RE: St. Lucie Units 1 and 2 and Turkey Point Units 3 and 4
Docket Nos. 50-335, 50-389, 50-250, and 50-251
Response to NRC Bulletin 2001-01

Turkey Point Units 3 and 4
Response to NRC Bulletin 2001-01

St. Lucie Units 1 and 2
Response to NRC Bulletin 2001-01

Figure 1: Turkey Point Units 3 & 4 Nominal Elevation Schematic of Components Above the Head

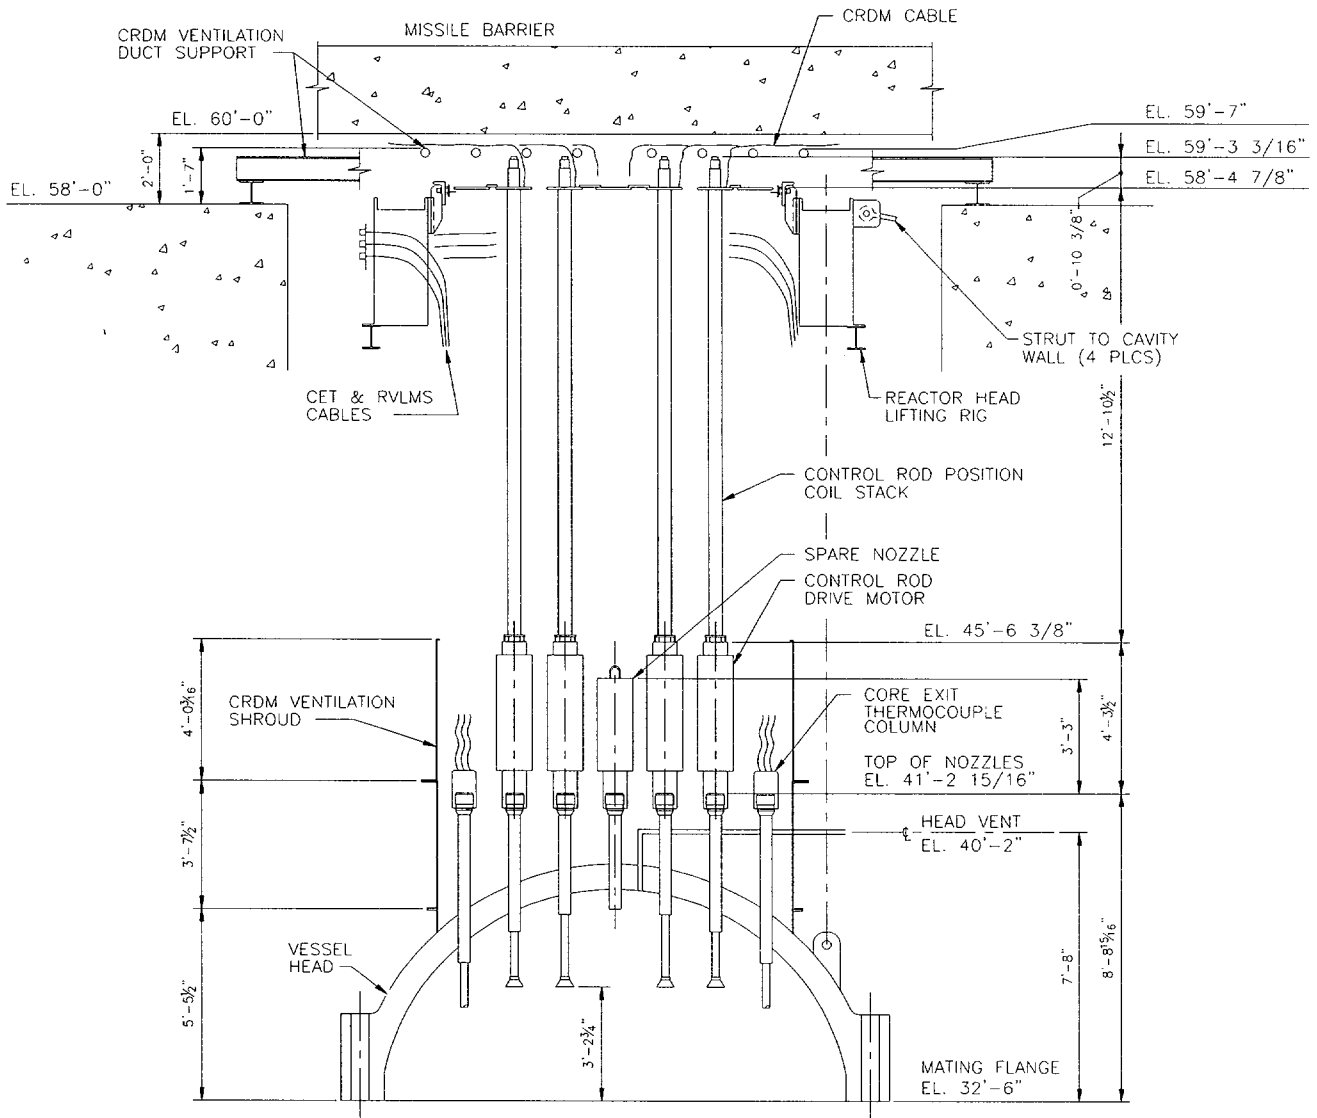
NRC Question 1e: a description of the configuration of the missile shield, the CRDM housings and their support/restraint system, and all components, structures, and cabling from the top of the RPV head up to the missile shield. Include the elevations of these items relative to the bottom of the missile shield.

FPL Response to NRC Question 1e: There are 66 reactor vessel head penetrations for each of the reactor vessels at Turkey Point Units 3 and 4. Of these, 45 are active CRDMs, 2 are used for the reactor vessel level monitoring system (RVLMS), 4 are for the core exit thermocouple (CET) columns, 6 are part length CRDMs with the lead screws retracted and pinned in the housing, 8 are spare CRDM nozzle penetrations with no current use, and there is one head vent penetration. Figure 1 shows a representation of the elevation view depicting the various components above the reactor head.

As shown in Figure 1, each of the CRDMs including the part length CRDMs are supported laterally at the 58'-4 7/8" elevation. The support is provided by capturing the square plates at the top of the control rod position coil stack forming a checker board configuration within the perimeter of the reactor head lifting rig box beam. Using a series of jacking screws along with dummy plates at those locations not containing a CRDM, these plates are captured with a clearance of approximately 1/4" between sides of adjacent plates. This checker board/ lifting rig assembly is then secured to the reactor cavity wall with four equal spaced rigid struts. The spare penetrations are fitted with a short, ventilation flow restrictor box that has no additional lateral restraint. For the CET and RVLMS penetrations, the assemblies terminate just above the nozzles with cable connections.

For the CRDMs, the cables rise a short distance as shown in Figure 1, are draped over and then tie-wrapped to a series of support elements that are part of the CRDM ventilation duct support. The cables are routed across these support elements to four quadrant points where the cables enter cable trays to exit to the plant.

Figure 1: Plan and Cross Sectional View of the St. Lucie Unit 1 RPV Head Insulation

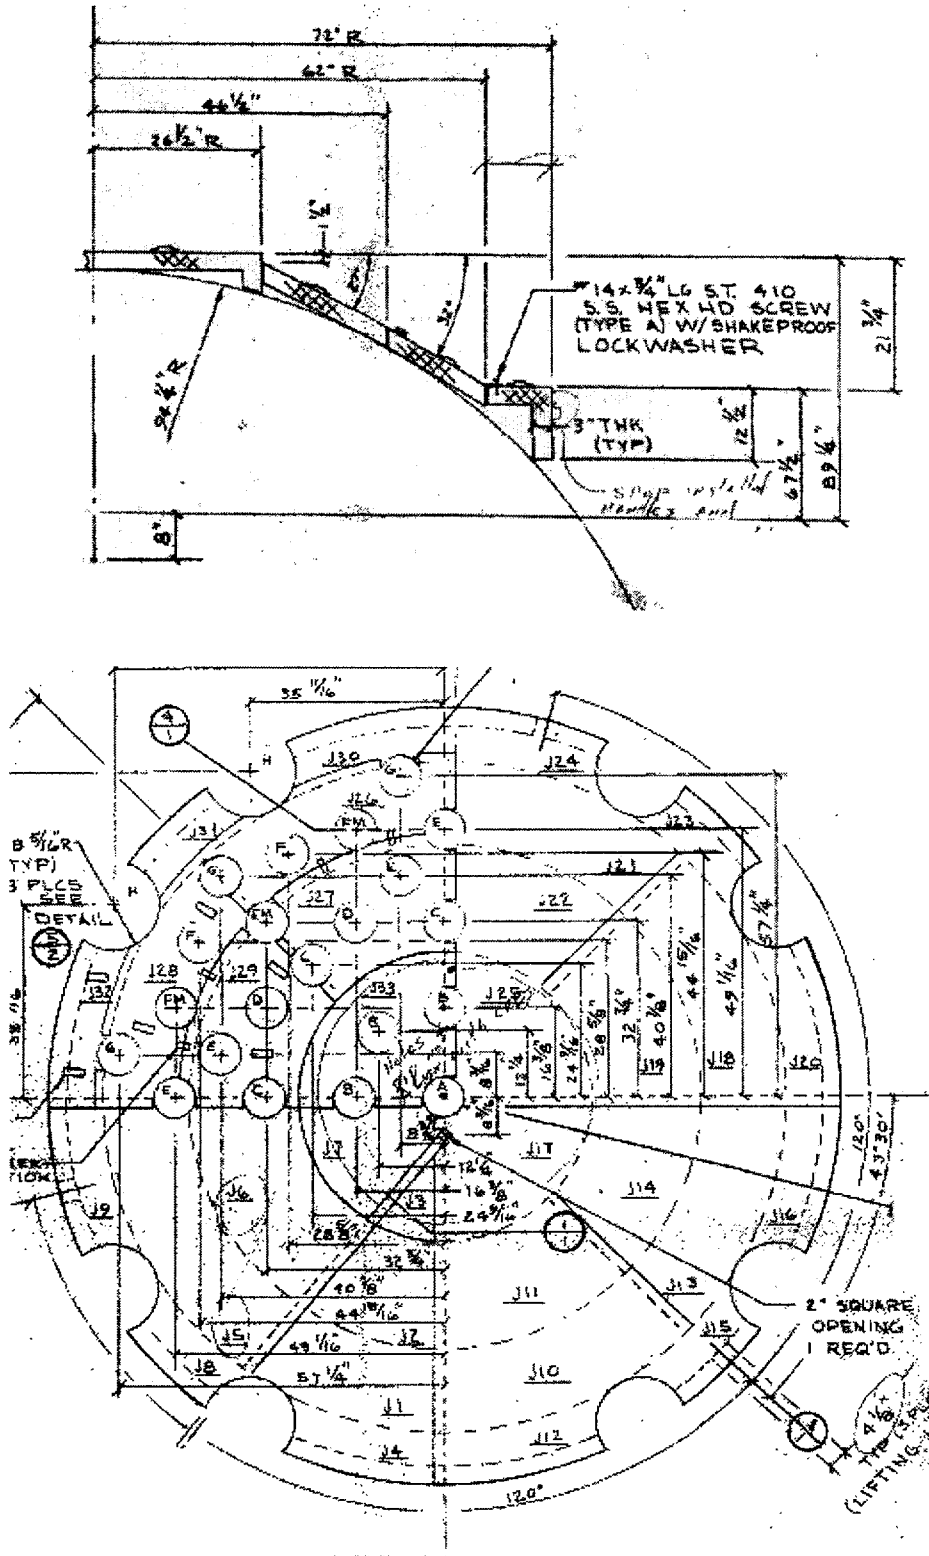
NRC Question 1c: a description of the RPV head insulation type and configuration;

FPL Response to NRC Question 1c: The insulation type at St. Lucie Unit 1 is metal reflective encapsulated mineral wool. The insulation conforms to the head as do the lower CRDM pressure housings. The insulation is made up of 33 panels, 21 of which encircle the 69 CRDM nozzles. The encircling panels were installed over the lower CRDM pressure housing flanges during initial construction. The gap between the insulation panels and the VHPs are filled with plug rings (containing asbestos insulation), that were installed prior to the panels and secured with a metal band. Figure 1 shows the general arrangement of the insulation.

Figure 5: St. Lucie Unit 2 Nominal Elevation Schematic of RPVH Components and The Missile Shield Above the Head (not to scale)

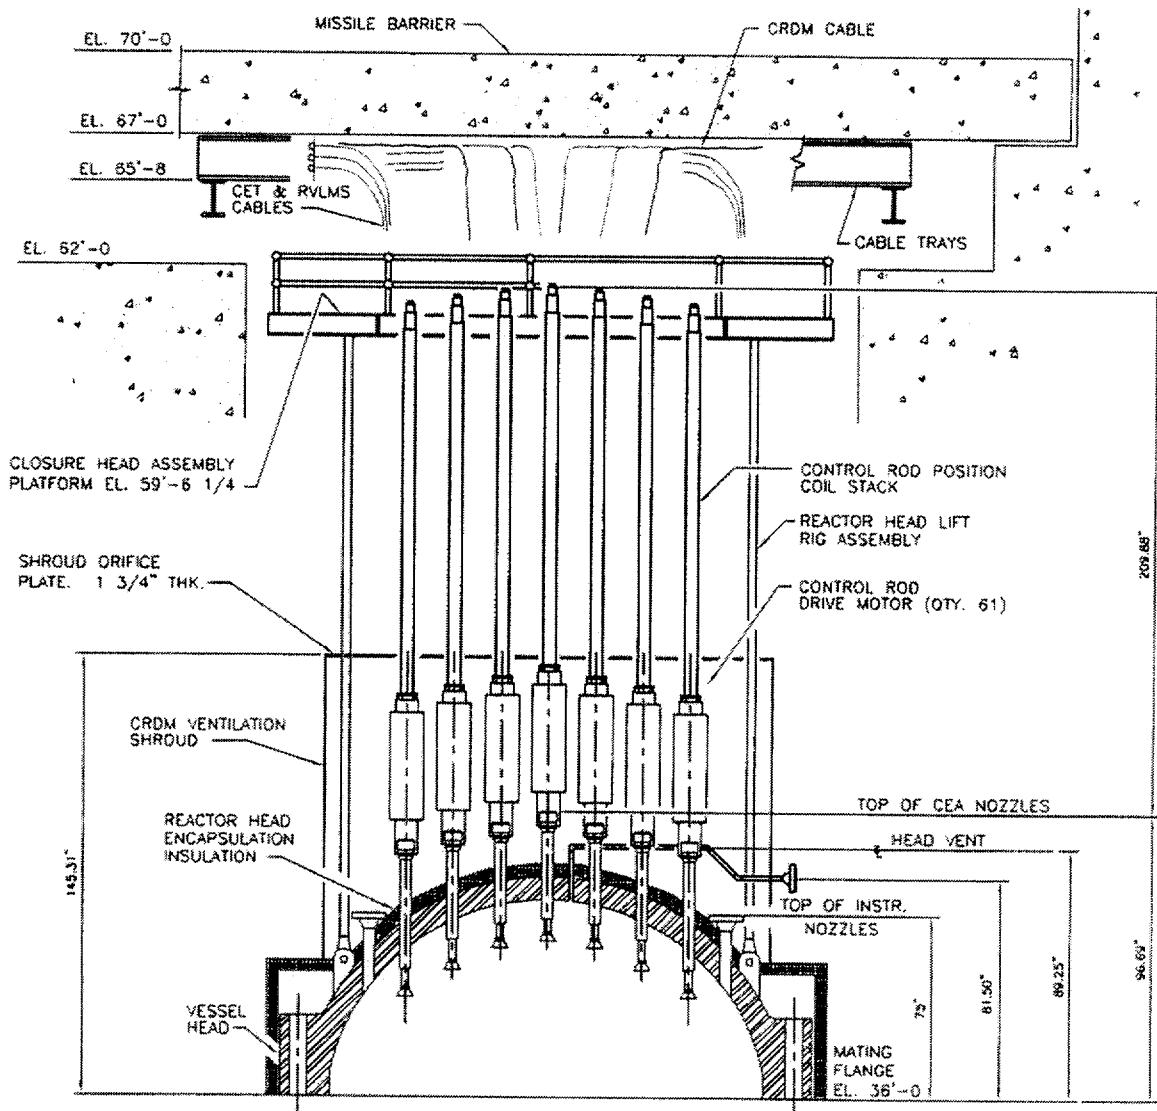
NRC Question 1e: a description of the configuration of the missile shield, the CRDM housings and their support/restraint system, and all components, structures, and cabling from the top of the RPV head up to the missile shield. Include the elevations of these items relative to the bottom of the missile shield.

St. Lucie Unit 2 - The bottom of the missile shield is at elevation 68.0 feet. The flange face of the RPVH is at elevation 36.0 feet. The separation from the reactor head flange face to the bottom of the missile shield is 32.0 feet. There are 91 CRDM nozzle penetrations, 10 instrument nozzles, and one head vent penetration. The relative height of each is shown in the attached Unit 2, Figure 5.
